**Re: BZA Order No. 18453--1728 14th Street, NW
Request for Minor Modification Per 11 DCMR, Section 3129**

This letter is submitted on behalf of 1728 14th Street LLC (the "Applicant") to request a minor modification to the approved plans. In this case, the BZA approved parking variance relief for three alternate building plans, with corresponding numbers in the amount of the parking variance required in each instance.¹ The BZA Order is attached. Also attached are two versions of Sheet A7A of the plans, showing the original BZA-approved cellar plan and the proposed revised cellar plan, as well as three versions of Sheet A2 of the plans, showing the square footage calculations for the building, which include the parking requirements. A supplemental memorandum from Wells & Associates is also attached. The filing fee of \$540.80 (20% of the original filing fee in this case) and BZA Forms 126 and 152 are also enclosed.

PROPOSED CELLAR FLOOR PLAN

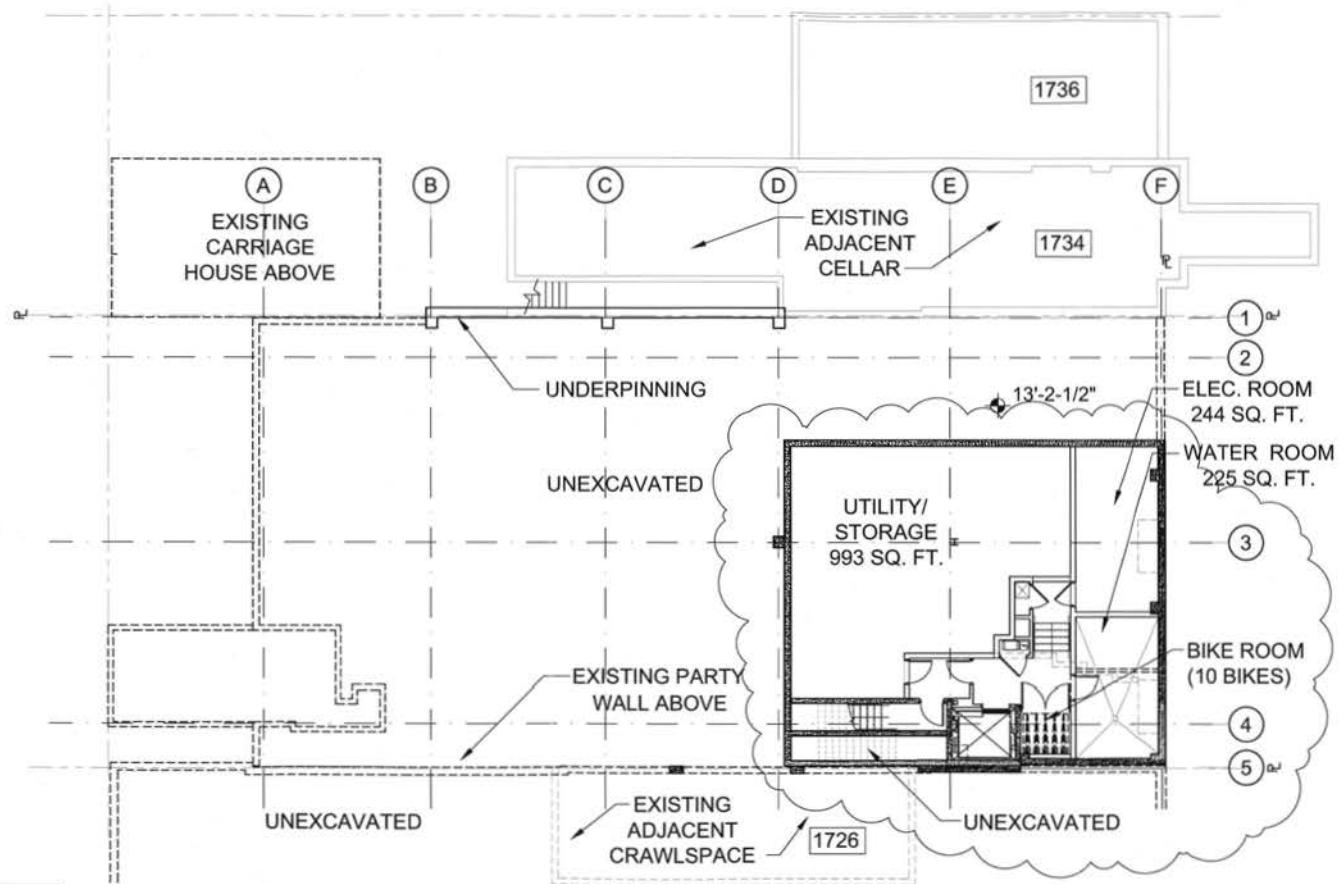
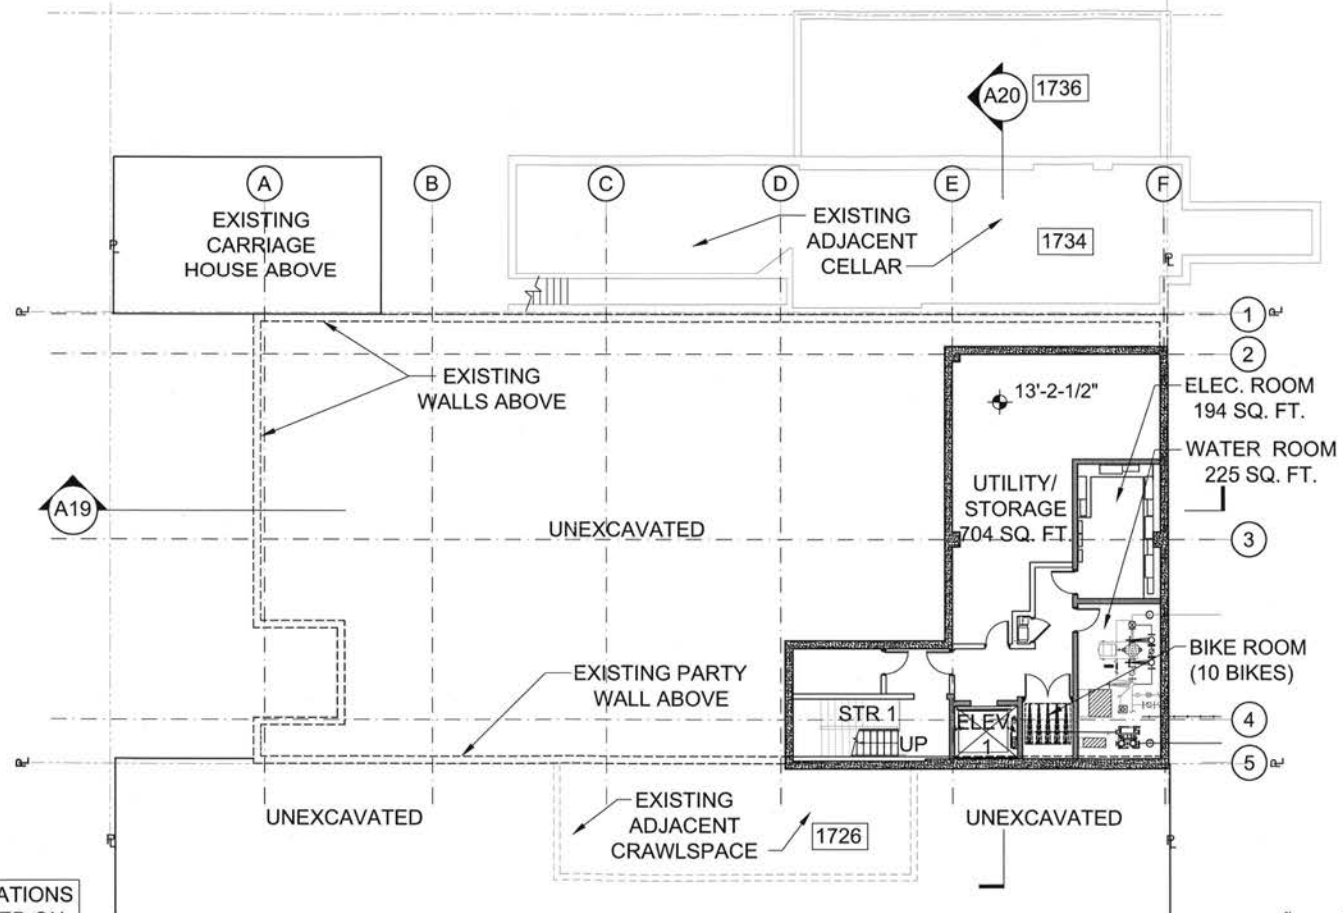
The owner wishes to modify the configuration of the cellar level. The modification will change the cellar configuration from an "L-shape" to a rectangular shape. This modified shape is dictated by the structural needs of the project, which require that the cellar excavation be set back an adequate distance from the building to the north. After the BZA process was completed, the structural engineer advised the Applicant that the location of the north wall of the cellar in the original plans was too close to the south wall of the adjacent building to the north to ensure the integrity of that building, which is a fragile historic structure. In addition, the stairway configuration to the cellar has been reversed, in order to minimize the amount of excavation along the property line adjacent to the historic structure to the south. As shown on the plans, the cellar reconfiguration corresponds to the locations of the grid structure. This reconfiguration slightly increases the size of the cellar by 108 sq. ft. (from 1992 sq. ft. to 2100 sq. ft.)
